ADDENDUM NUMBER: Two (2)

TITLE: District II Building 6 Renovations – Design Phase 1412186879

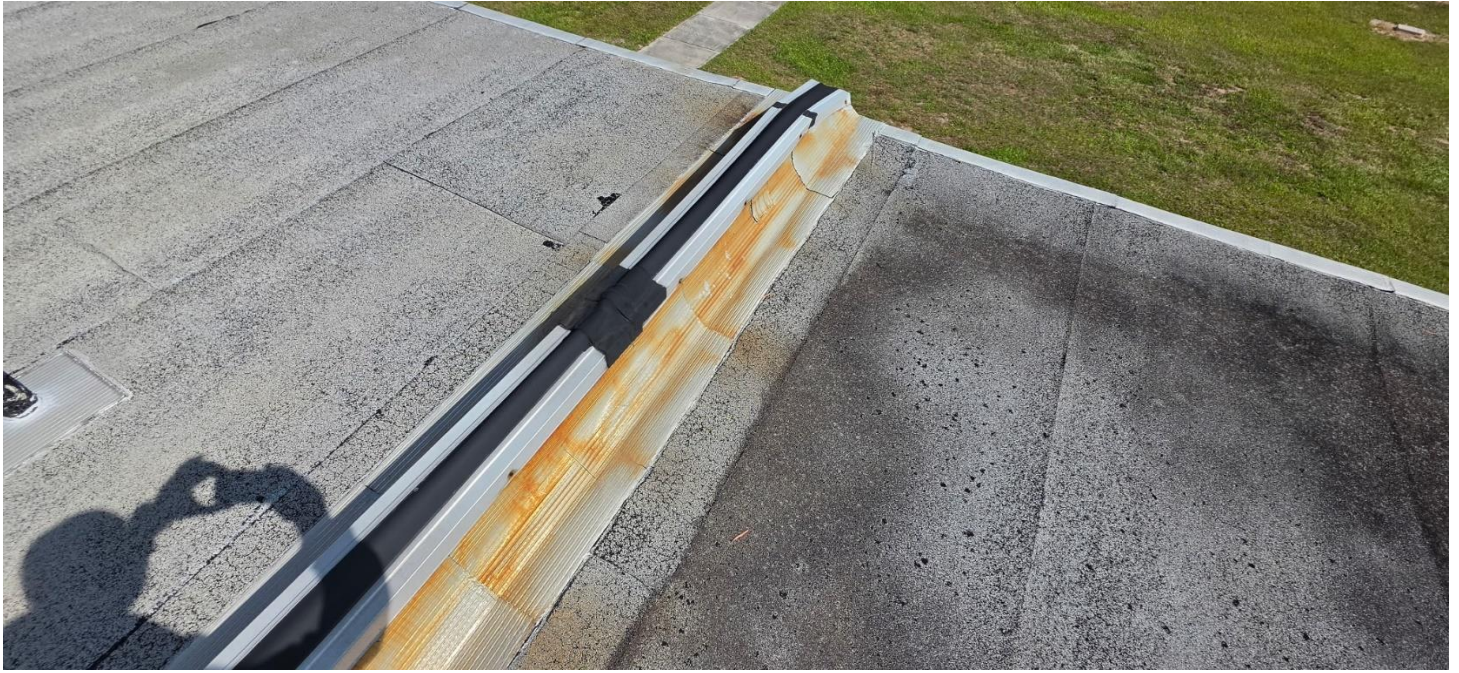
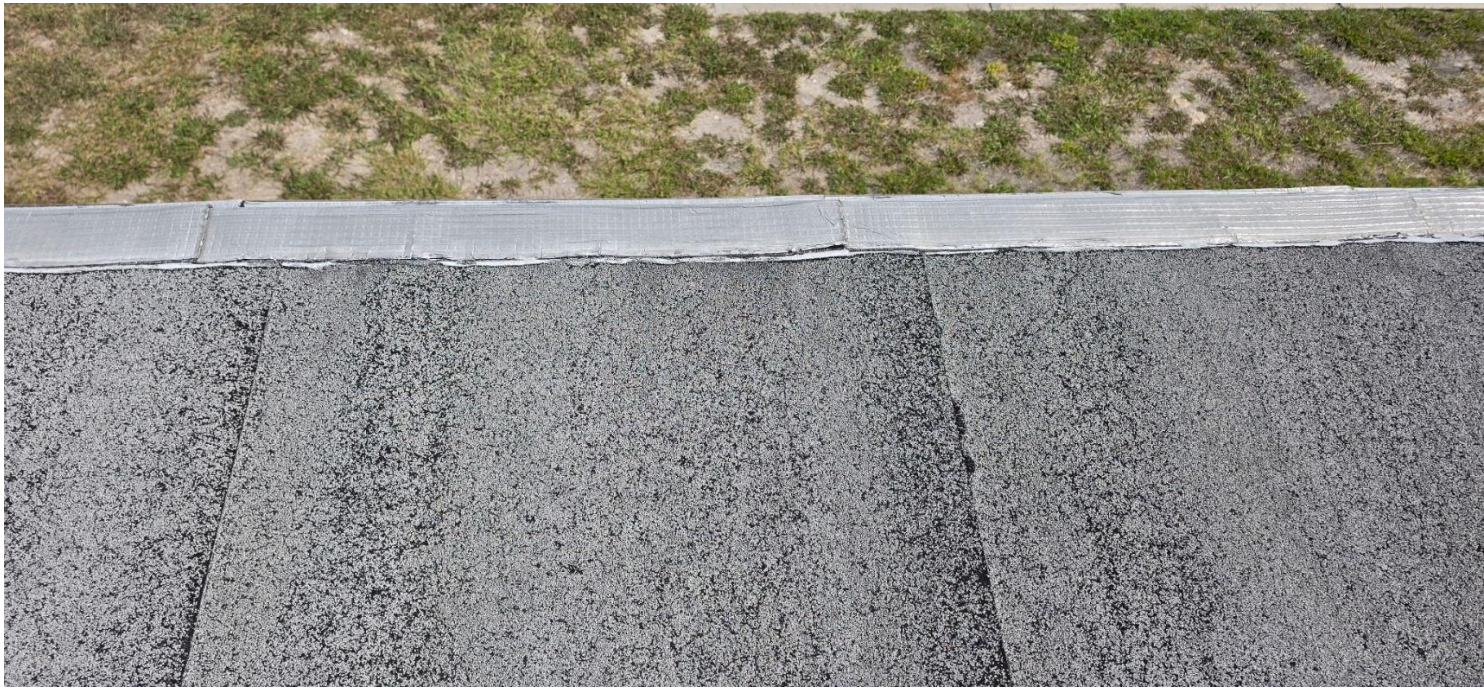
7. **The photos below are included to provide clarification regarding the Building 6 roof conditions observed during the site visit.**
